Amendment to Plan - Mercy Hospital

Mercy Hospital

**RE: Mercy Hospital – Amendment to Plan
Vicinity of Fore River, Portland ME
Application ID Number: 2007-0005; Chart 073, Block A, Lot 1001**

Re: Mercy at the Fore - Revised Elevations

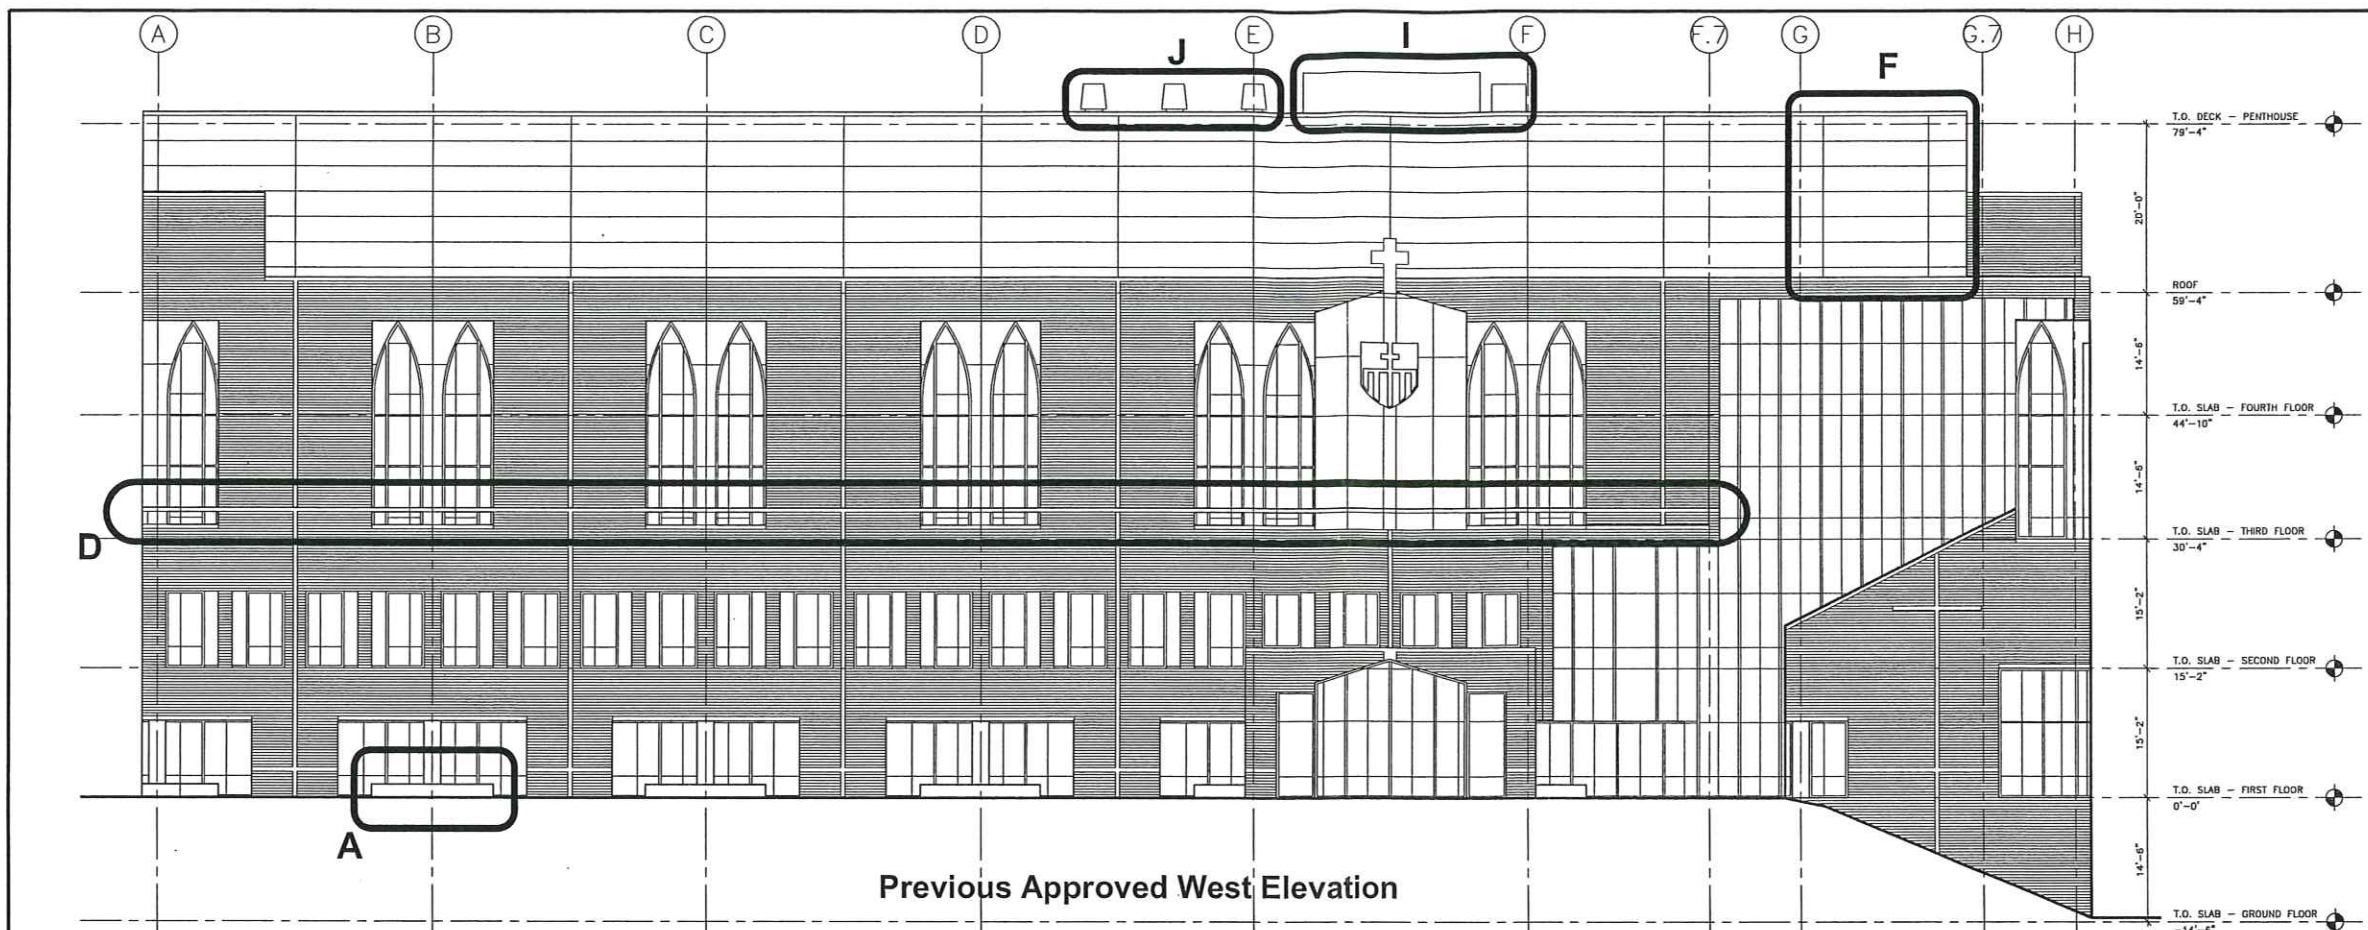
O) Windows replaced on north elevation.

The window was deleted for budget reasons, and the overall design intent was not affected.

Note: The North Elevation shows a reduction in window area.

There appear to be revisions to the North Elevation that show a reduction of window area at the top floors, and the lower level. These changes were not noted by the applicant in the submitted memo. This matter should be further clarified.

Previous Approved West Elevation

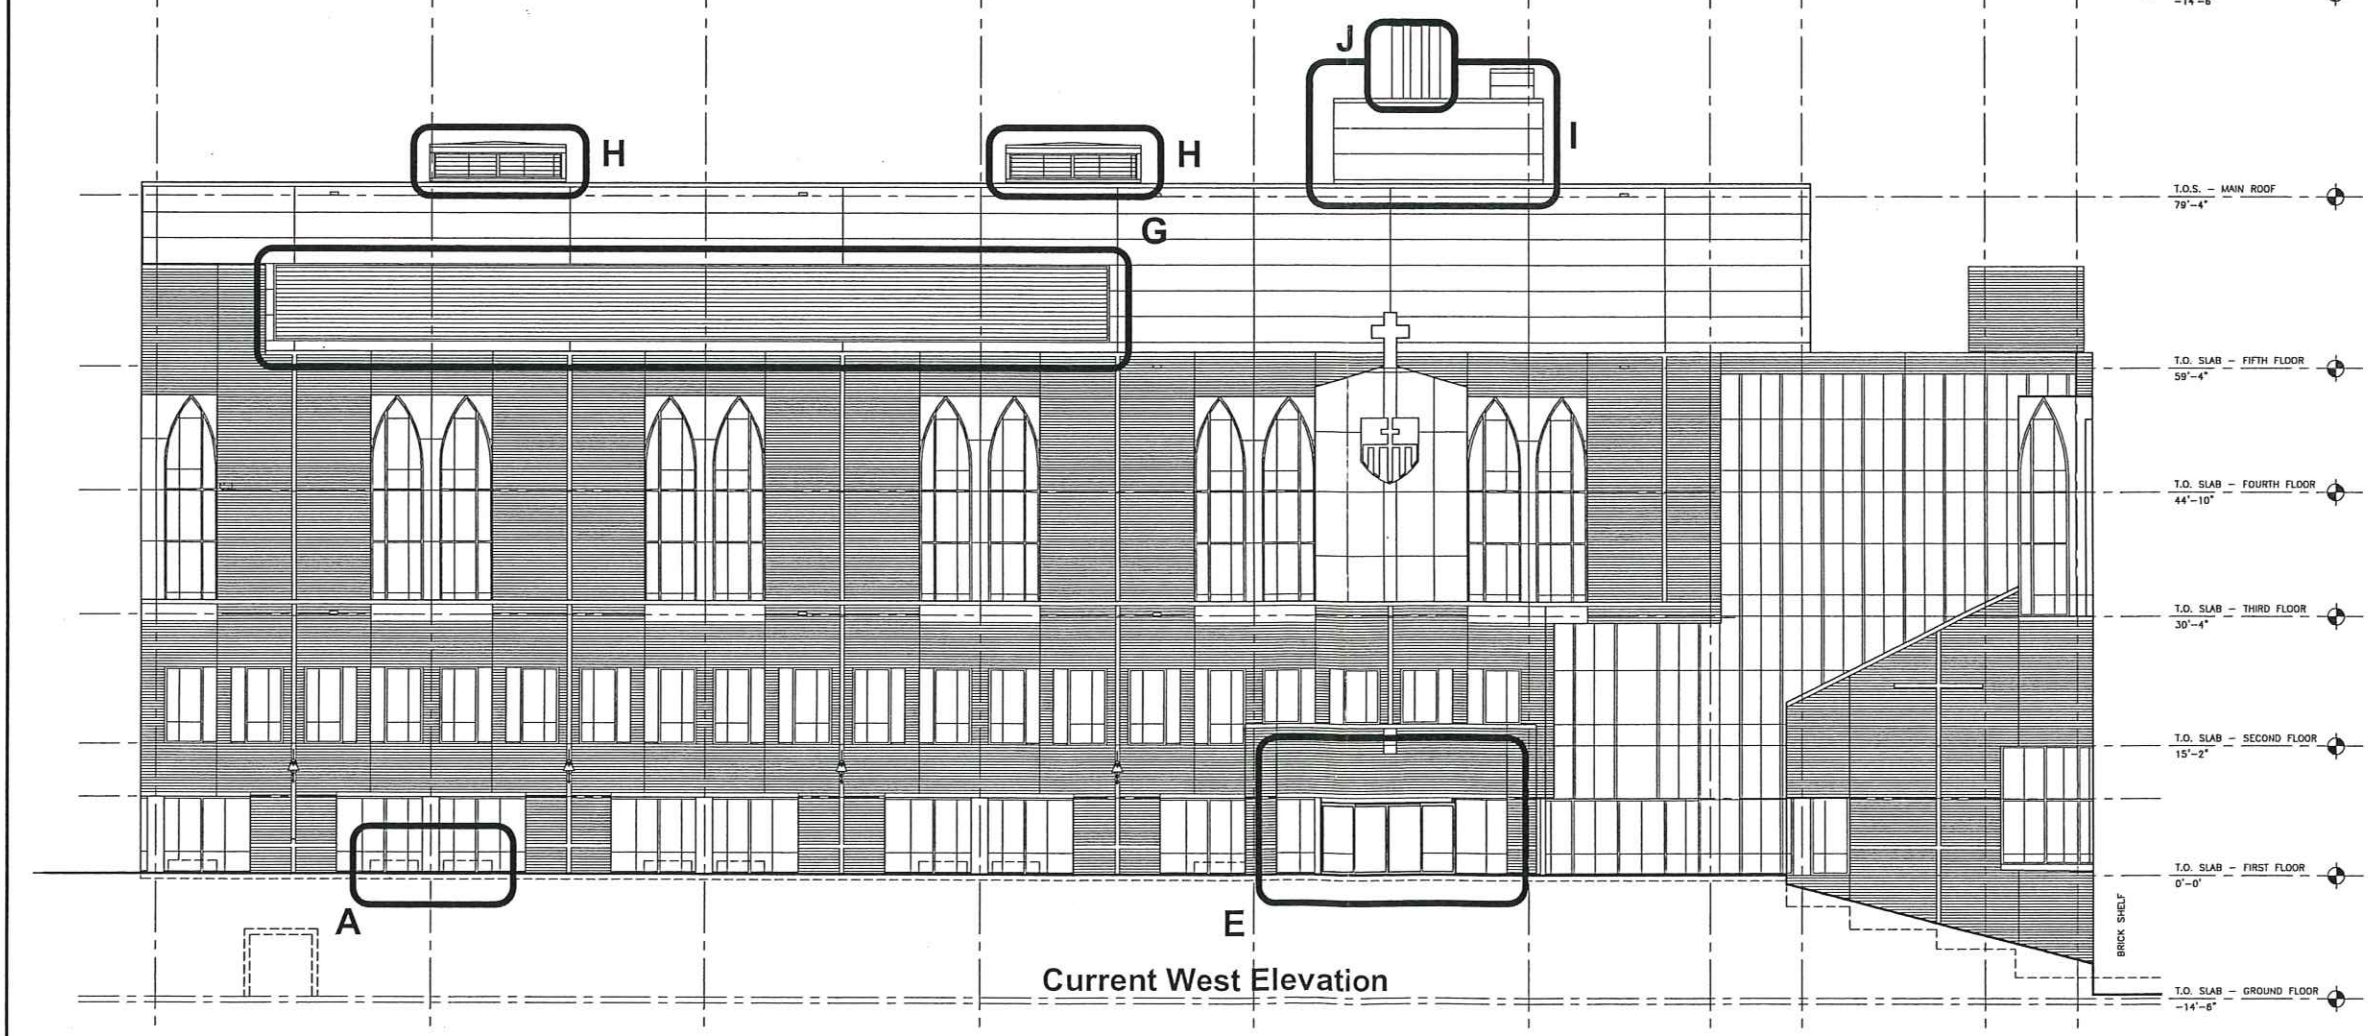
✓ **A. Deletion of granite clad benches from the west façade at the arcade level.**

The granite benches which were approved along the front façade have been eliminated. It would be desirable to have benches as an amenity to the users of the building. This item should be discussed.

G: The air intake louvers have been moved from the east to the west façade.

This item warrants further discussion. The visual and aesthetic impact of the change of the location of the air intake louvers to the front (west) façade of the building is cause for consideration.

1. That the applicant will provide some seating at the arcade level on the west elevation prior to the issuance of the Certificate of Occupancy.

Previous/Approved East Elevation
Current East Elevation

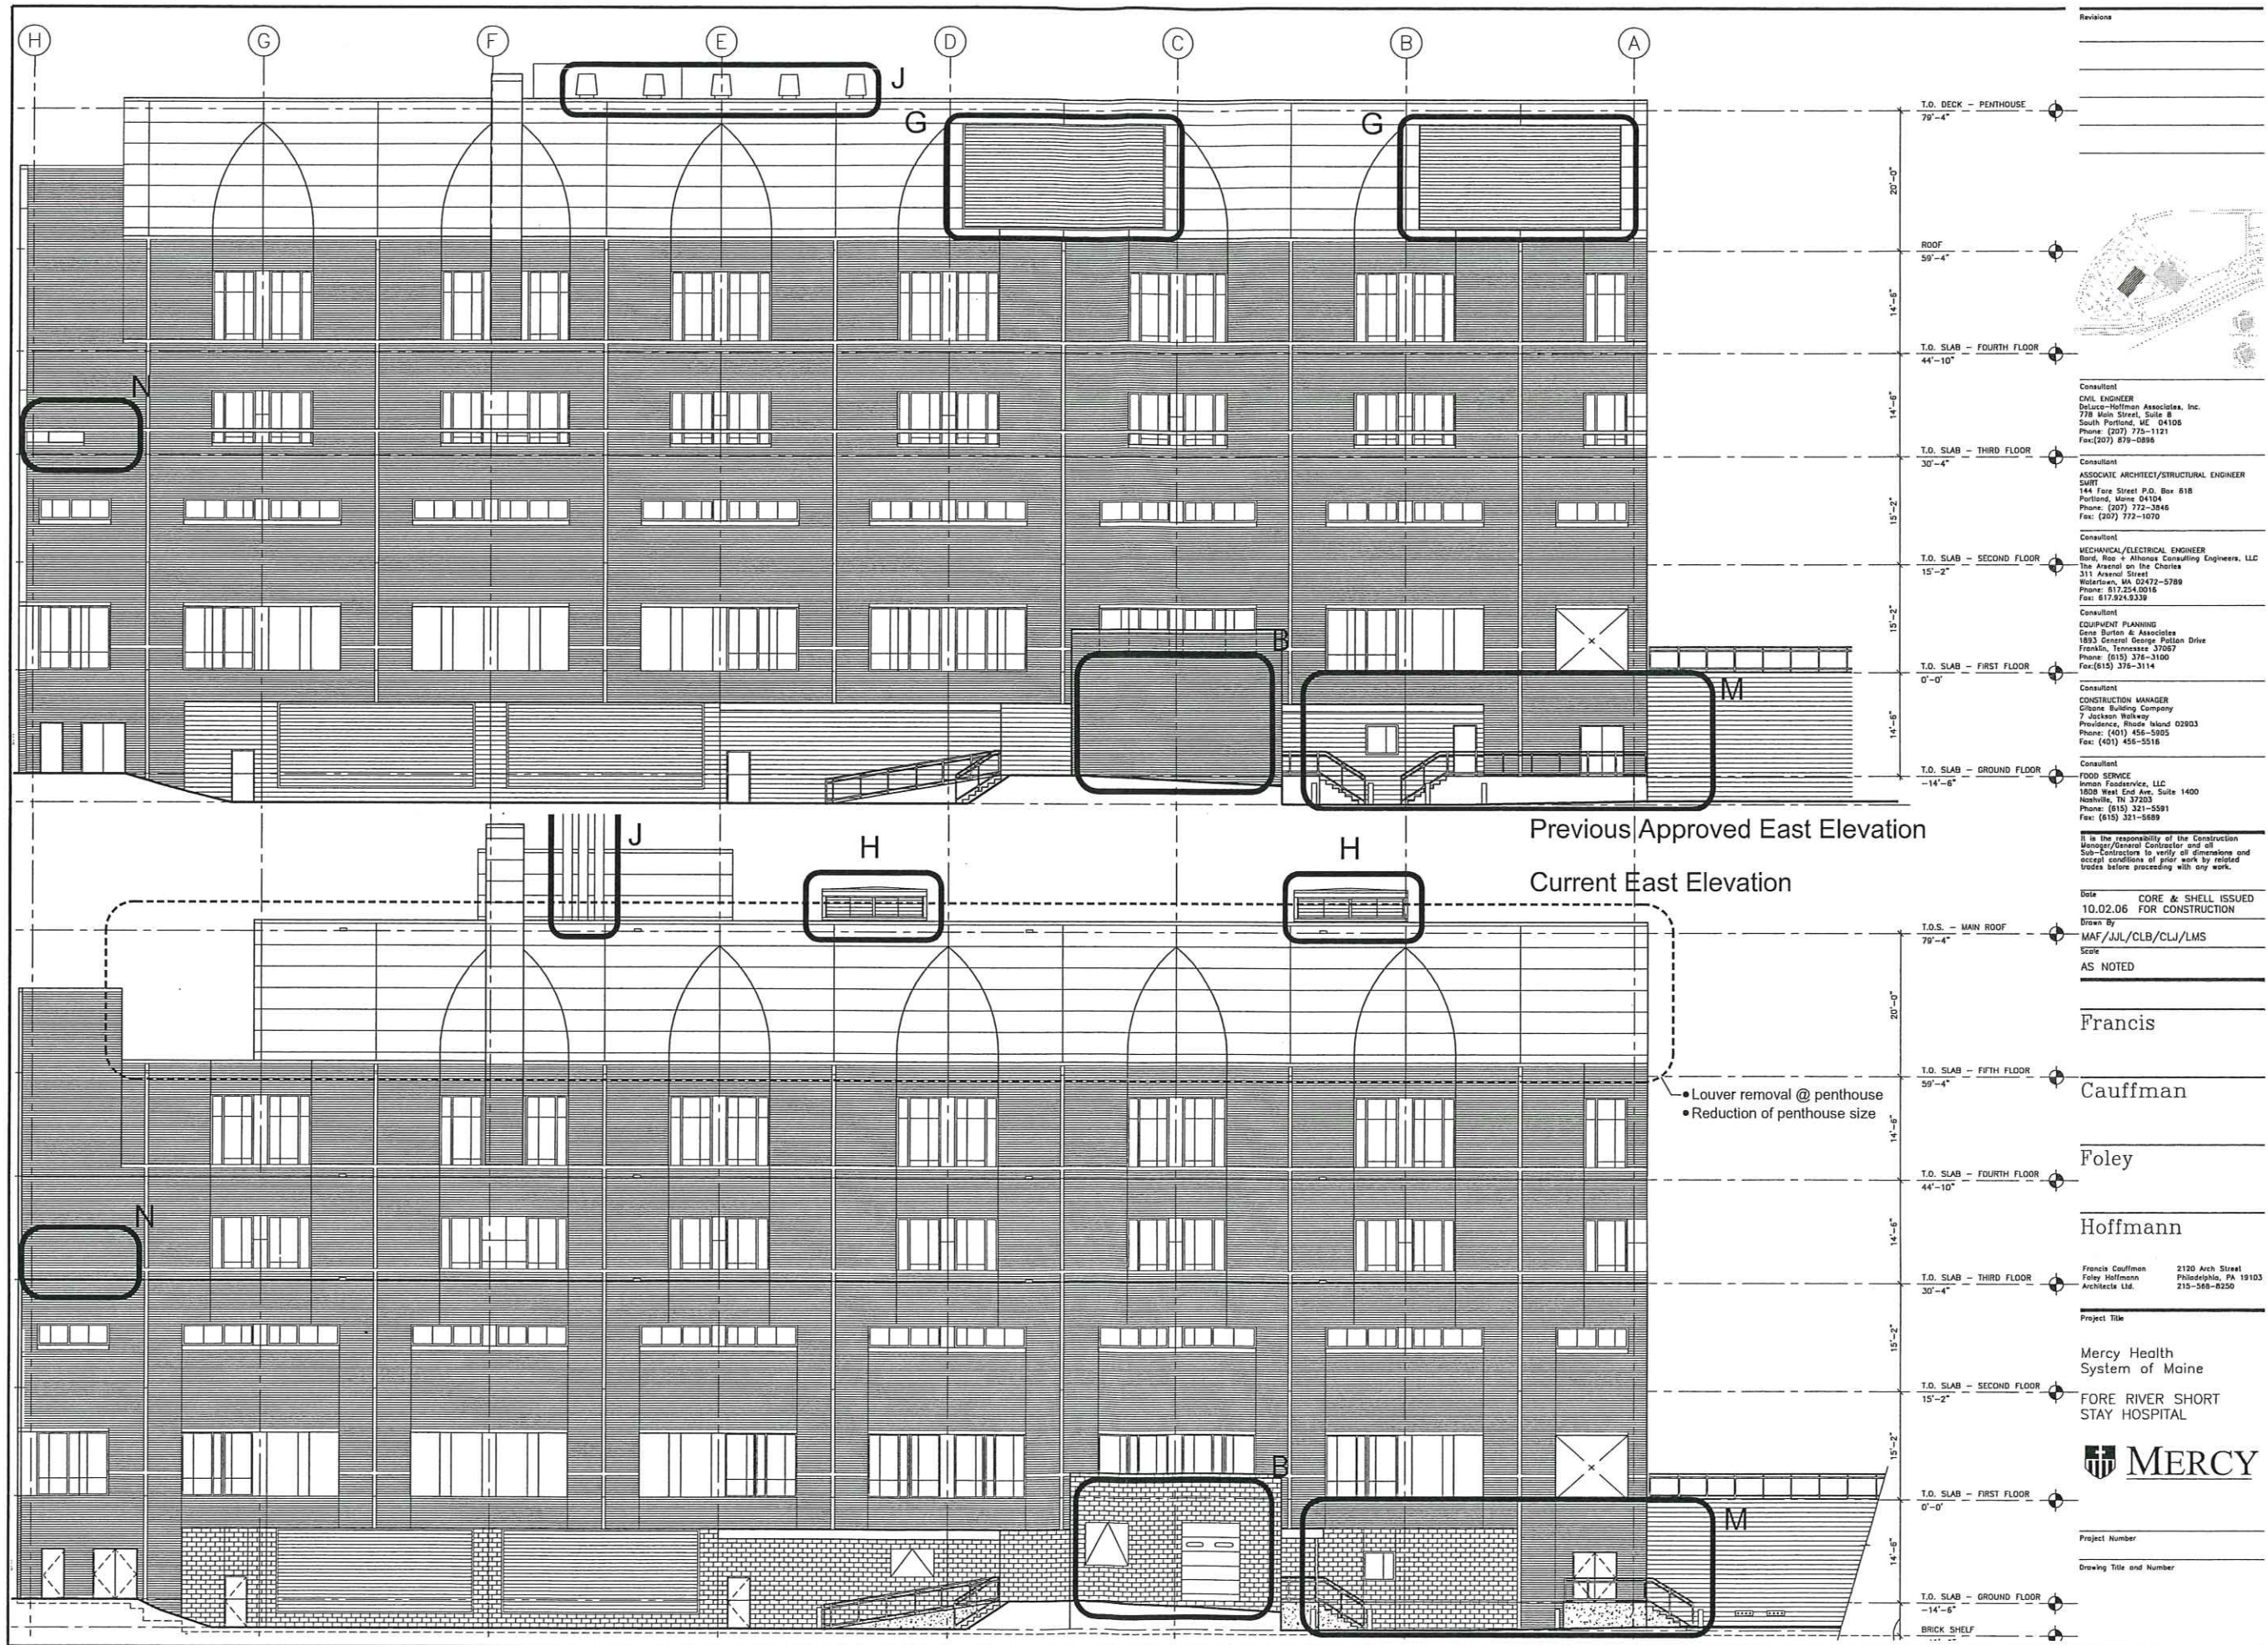
- Louver removal @ penthouse
- Reduction of penthouse size

✓ **B. A 2-bay dock will be built instead of a 4 bay dock at the east elevation.**

This is an acceptable change.

Note: Changes to the East Elevation at the lower level.

There appear to be revisions that have been made to the lower level at the East Elevation. These changes were not noted by the applicant in the submitted memo, but are acceptable as shown.

Mechanical Penthouse Floor Plan- Previous Layout
 Scale: 3/32"=1'-0"

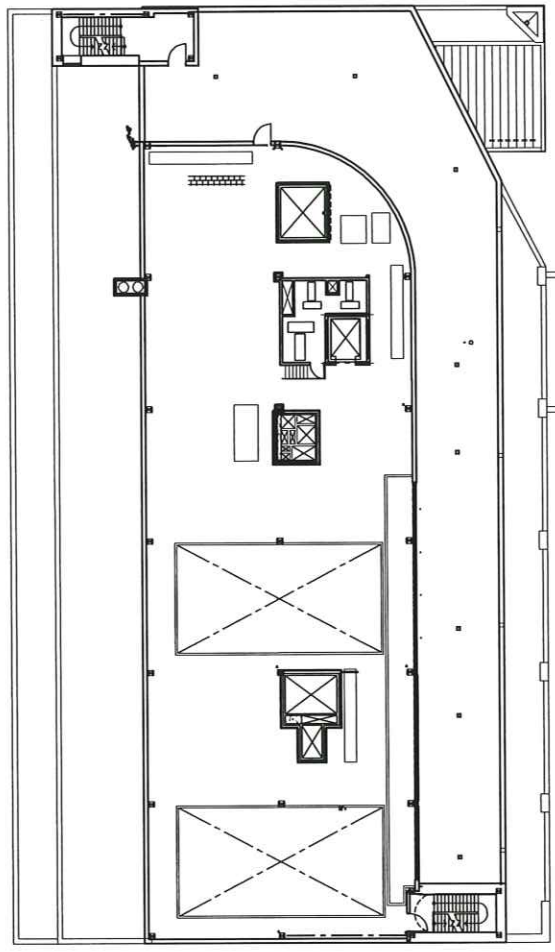
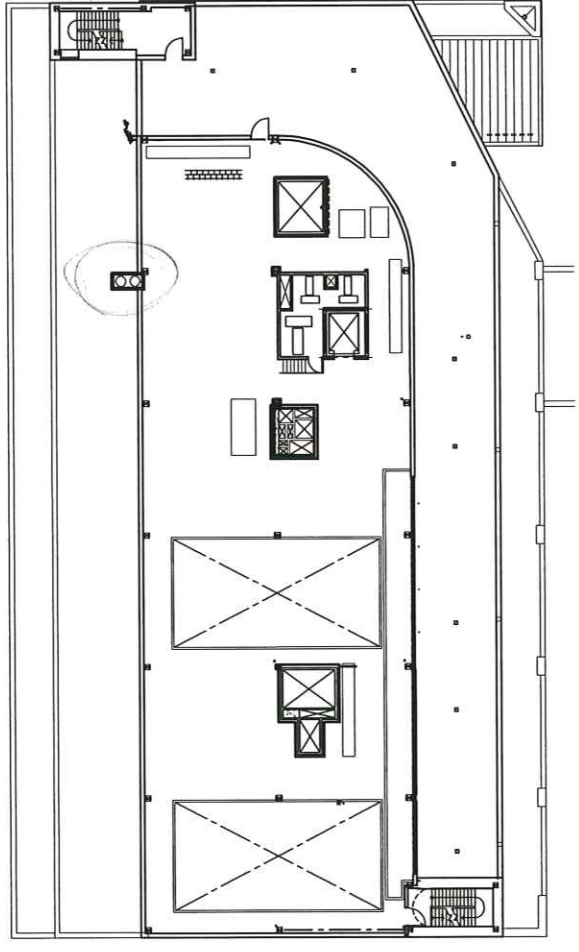
F) Reduce the size of the penthouse at the south end.

Final building space programming has allowed a reduction of the penthouse storage area. Thus, the penthouse length has been reduced by 18 feet horizontally.

F. The penthouse size at the south end has been reduced.

This item warrants further discussion. The reduction in the size of the penthouse at the south end of

the roof creates a gap in the roofline of the building. From a design perspective, it is desirable to have a penthouse that is the full length of the building, in order to read visually as the building's "top", and to create a clean line and cohesive image overall.
